# Gear Motor Retrofit Kit

This gear motor retrofit kit replaces the gear motor originally installed in the machine which is no longer available from the supplier. The motor manufacturer has replaced the motor it previously manufactured with a similar motor with slightly different dimensions and a slightly different envelope. The mounting pattern, drive shaft length and size and motor capabilities are unchanged, but the housing of the new motor is slightly shorter in height and approximately 0.354 inches (9 mm) larger in diameter than the previous motor. The diameter has increased from 4.96 inches to 5.315 inches (126 mm to 135 mm).

# Motor Retrofit, SB-HD Side Belt Heavy Duty Case Taper

# Motor Retrofit, Print Station for VCTS / VCTS-XL

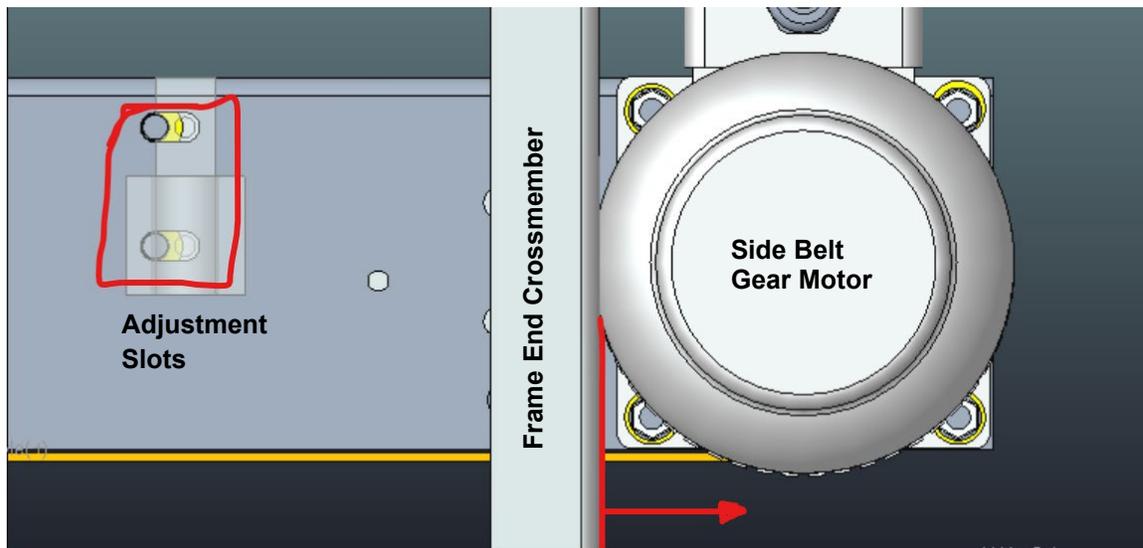
Following is a screen capture from the CAD model showing the gear motor and taper frame as viewed from the underside. Indicated at the right in red, is where the new larger diameter gear motor housing will interfere with the case taper end crossmember. Indicated in the red rectangle to the left are two slotted adjustment holes where bolt locations must be adjusted to provide adequate clearance for the new gear motor housing.

**Side Belt Assembly Attaching / Adjustment Slots**

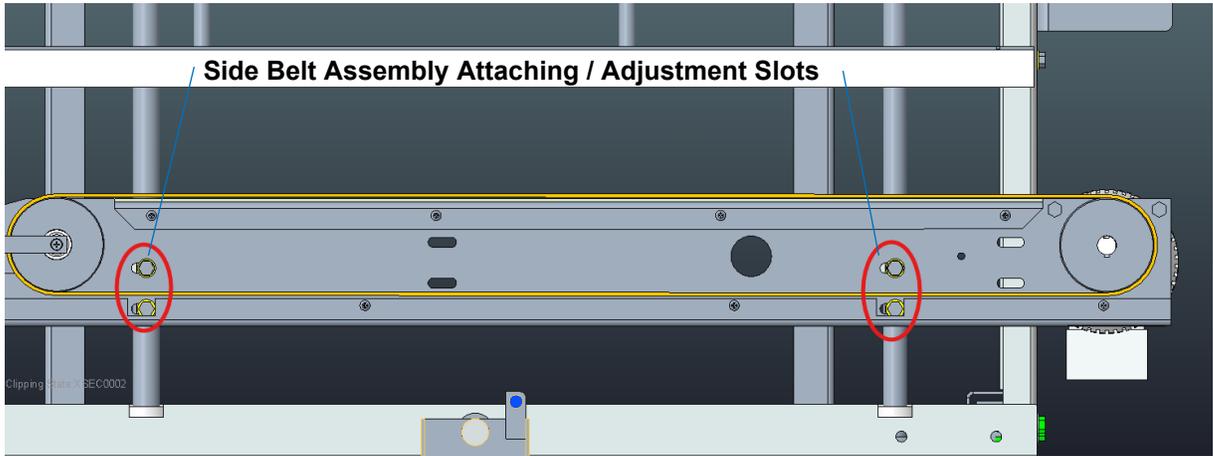
The following CAD model screen capture shows the locations of the bolts and adjustment slots that allow for repositioning of the side belt assembly. Adjust the side belt assembly position as needed to provide clearance for the side belt gear motor.

b. Reuse original hardware removed in Step 1 to secure the new replacement gear motor in place, loosening the bolts in the adjustment slots and adjusting the location of the side belt assembly as required. When the gear motor is secured in place, re-secure the bolts in the adjustment slots to secure the side belt assembly. Reattach the side belt assembly cover using the Phillips cap screws removed earlier, and reinstall the belt tensioning bolt at the case infeed end of the side belt. Refer to the SB-HD User Guide to adjust the belt tension and tracking after installation of the replacement motor and reinstallation of the side belt cover.

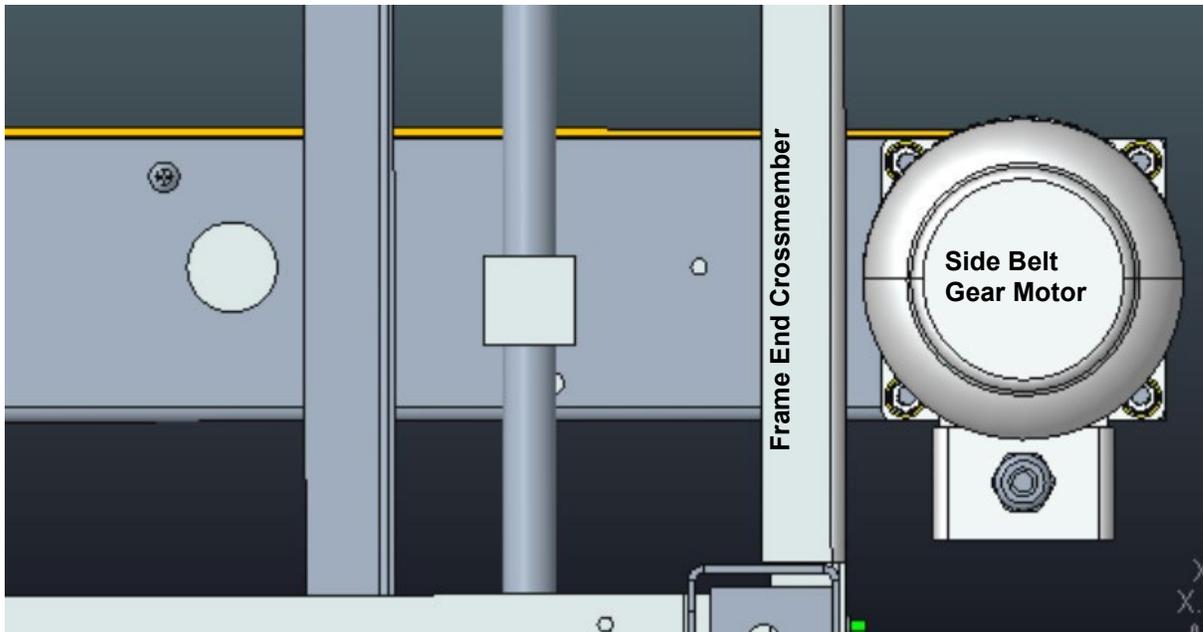
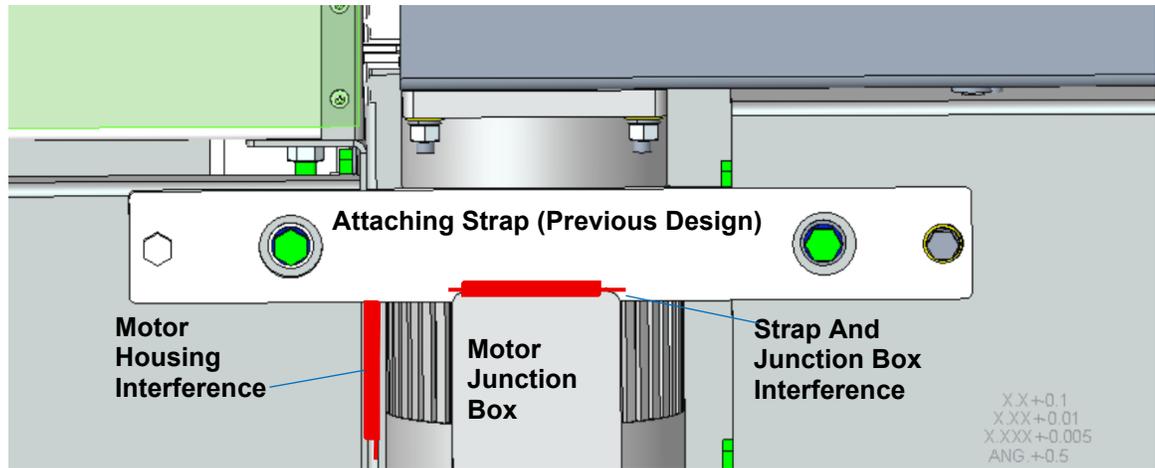
The following CAD model screen capture shows the replacement side belt gear motor installed with adequate motor housing clearance with the frame end crossmember.

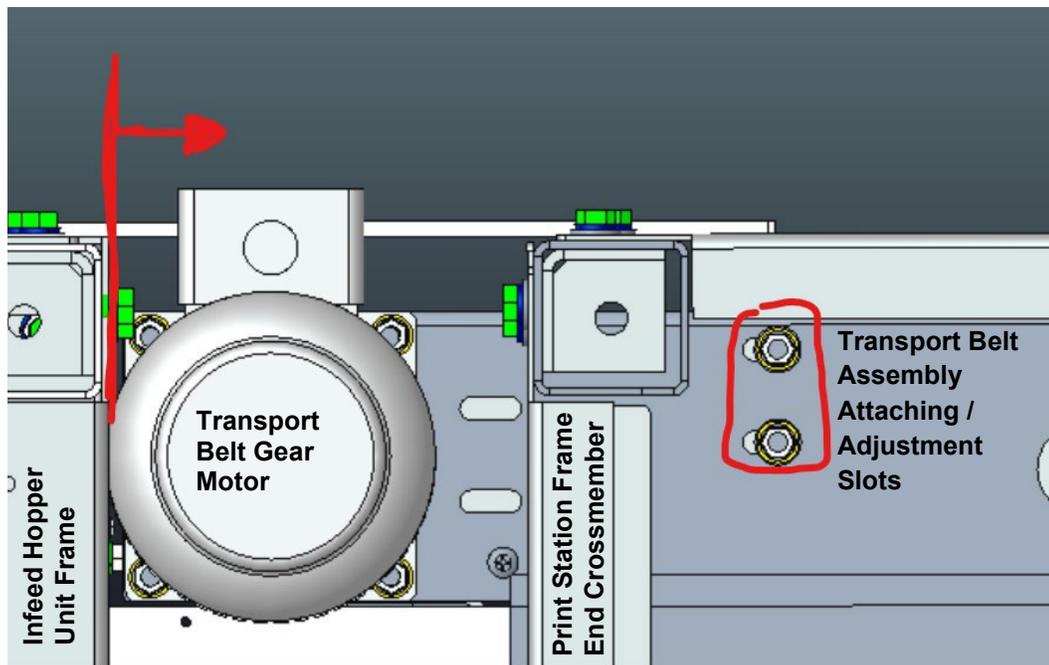
Following is a screen capture from the CAD model showing the gear motor and frames of the input hopper module and print station from the underside. Indicated at the left in red, is where the new larger diameter gear motor housing will interfere with the infeed hopper frame. Indicated in the red rectangle to the right are two slotted adjustment holes where bolt locations must be adjusted to provide adequate clearance for the new motor housing.

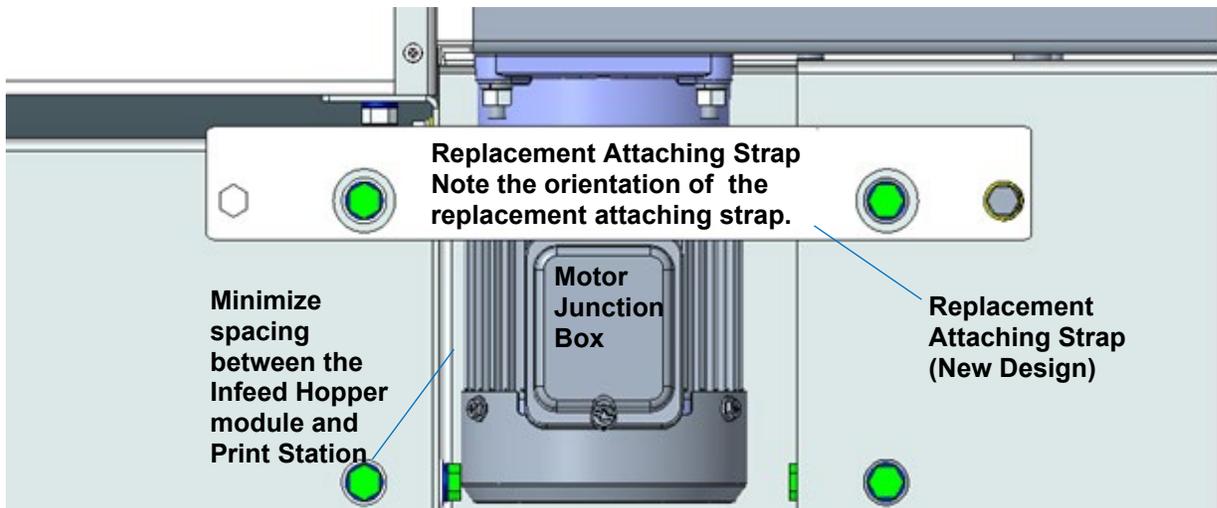
**Note**: Install the attaching strap in the orientation shown below so the fastening holes are closer to the bottom edge of the attaching strap than they are to the top edge. Note the orientation of the strap as shown below.

**c.** Refasten the Print Station to the Infeed Hopper module using the replacement attaching strap provided with the kit and using the attaching hardware removed earlier.
